KETCHIKAN, ALASKA KTN AIRPORT FERRY TERMINAL TO THIRD AVENUE SURFACING

AIRPORT FERRY TERMINAL TO THIRD AVENUE, PHASE 1
PROJECT No. NHS-IM-000S(495)~68366

TONGASS AVENUE WATER & SEWER MAIN REPLACEMENT

AIRPORT FERRY TERMINAL TO THIRD AVENUE, PHASE 1
PROJECT No. RSA 68830 / RSA 68831

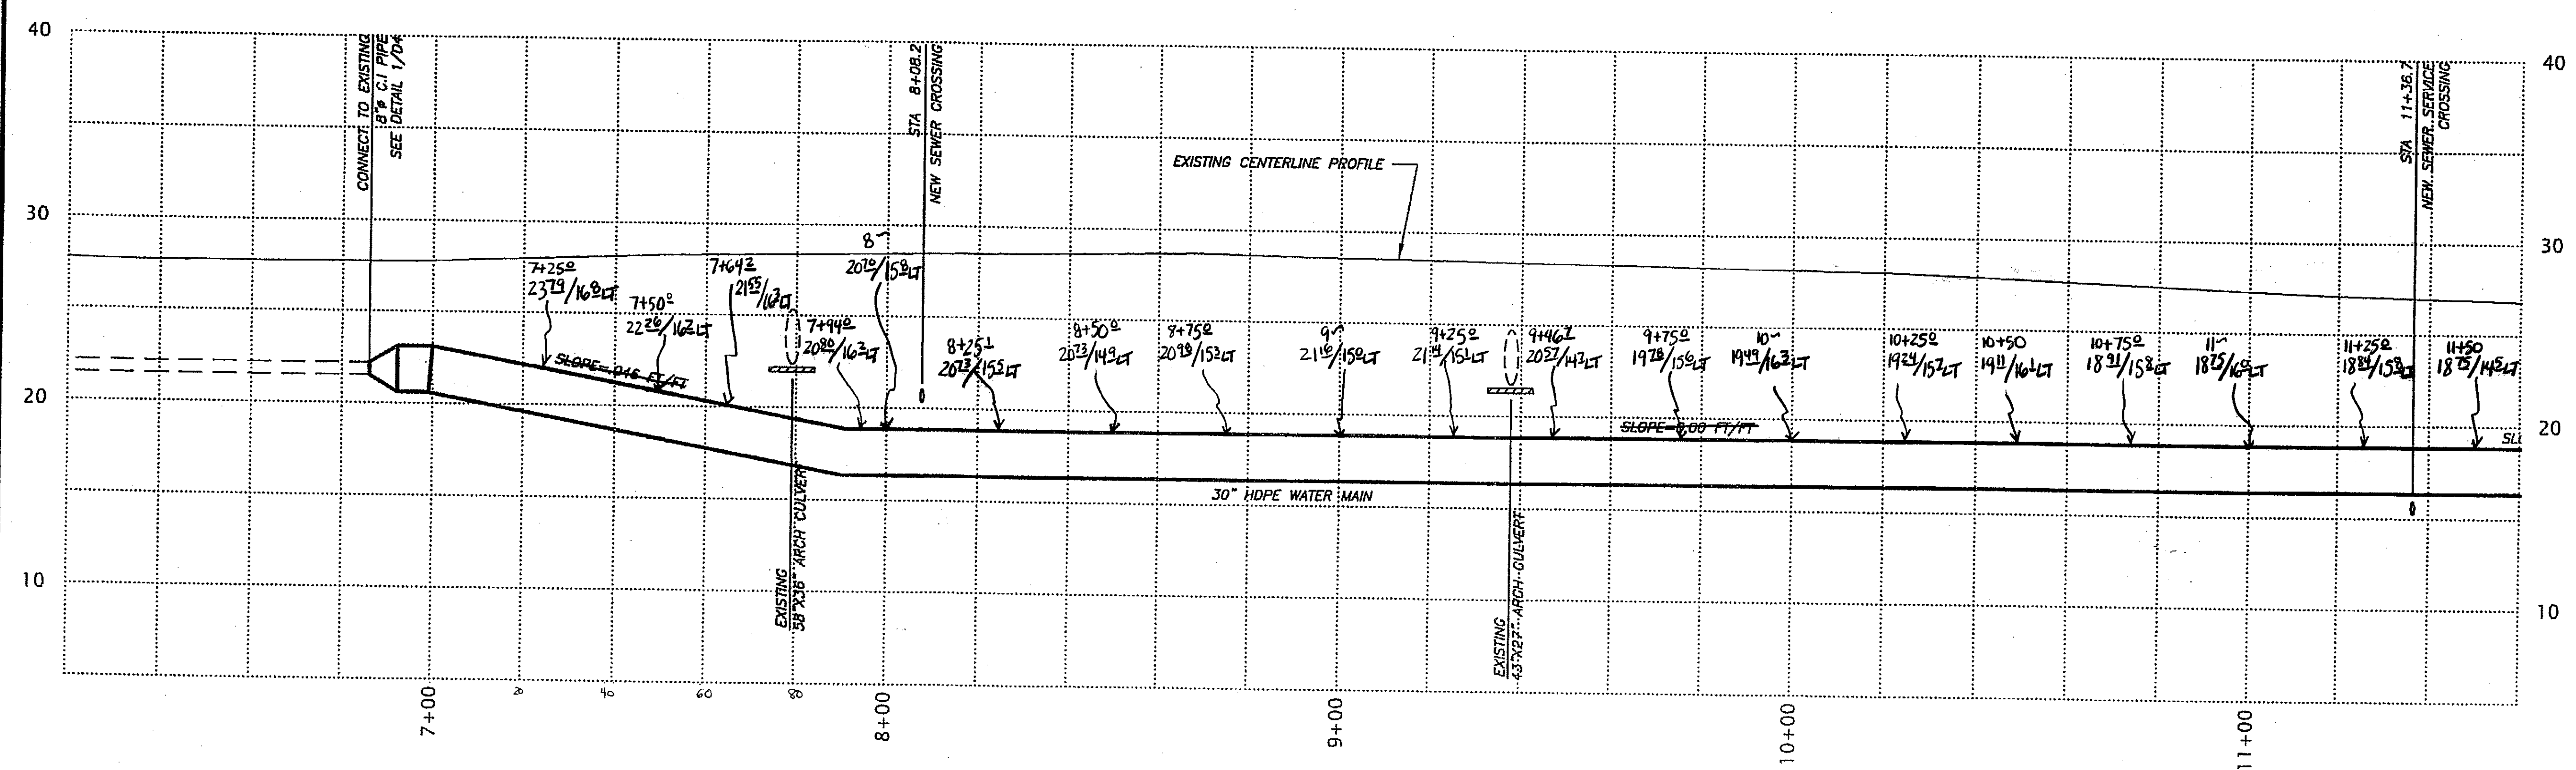
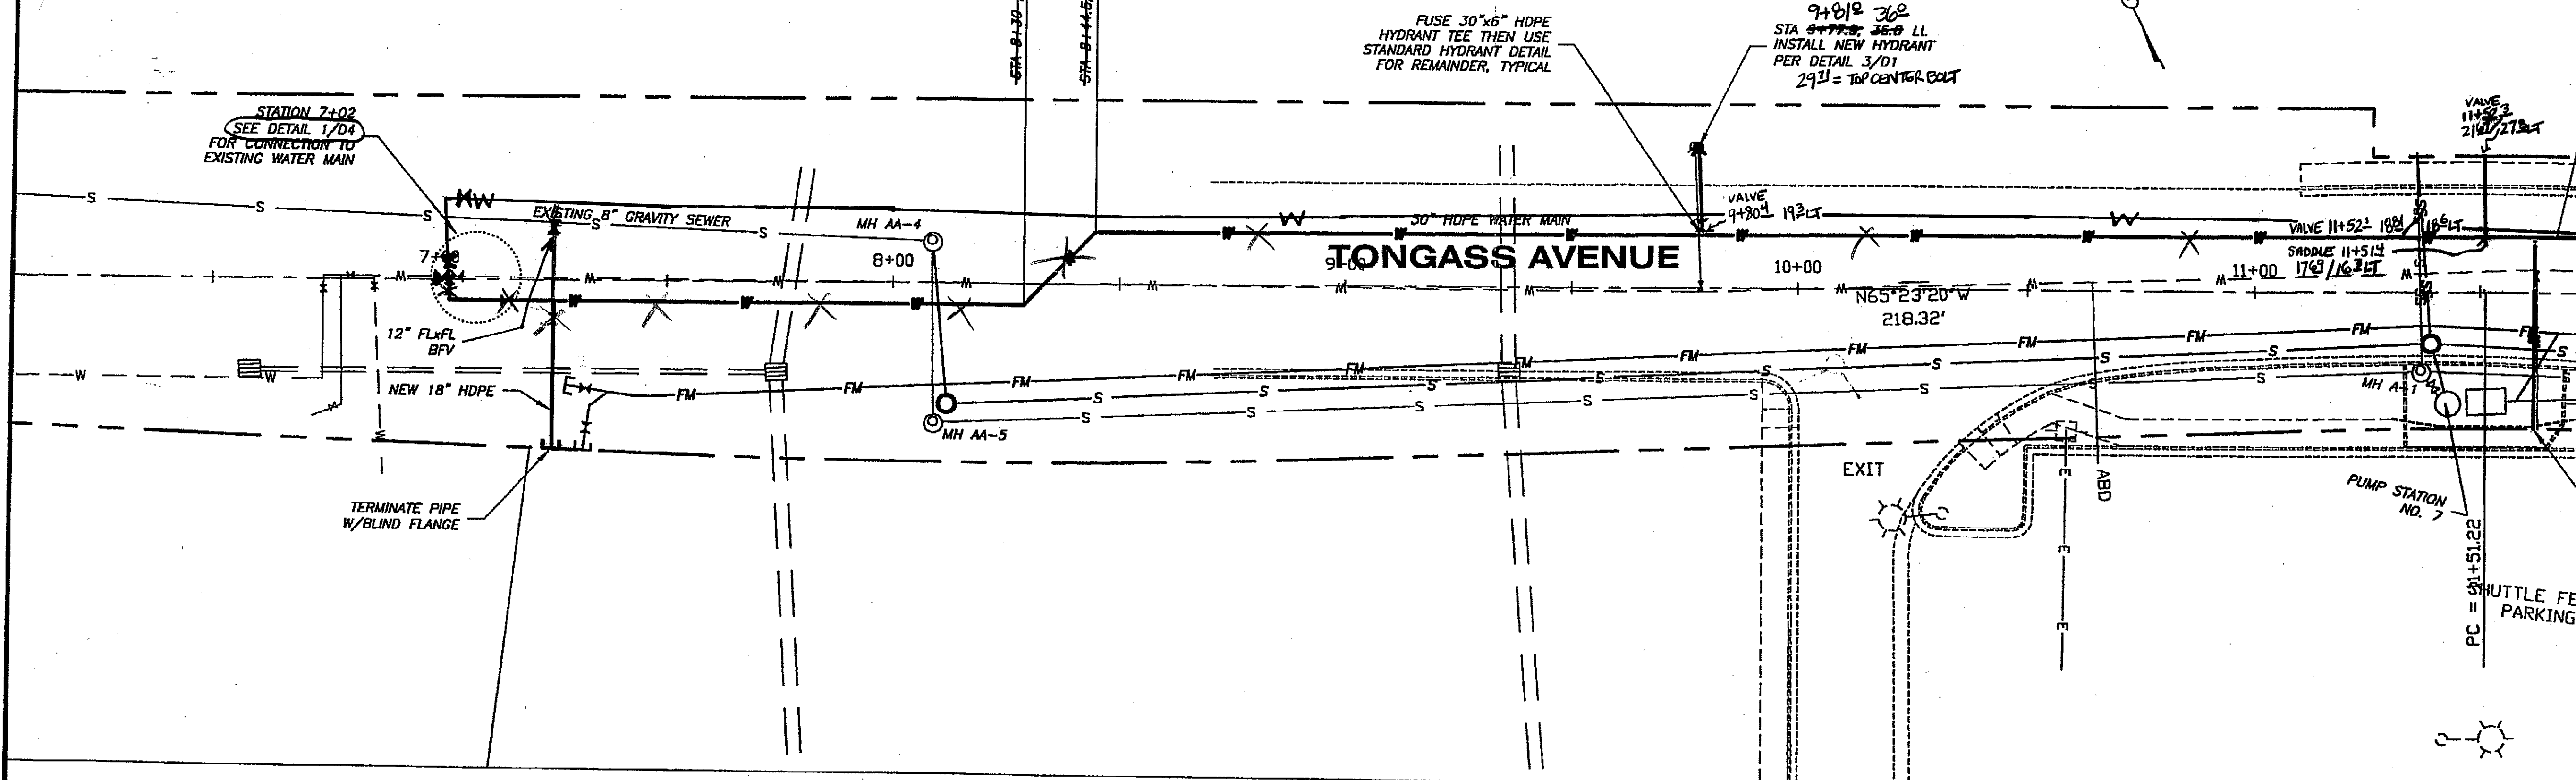
NOTE: 30" HDPE Alignment shifted to ~15' LT. BOP to M1+50 to Allow for 2-Way Traffic during Construction.
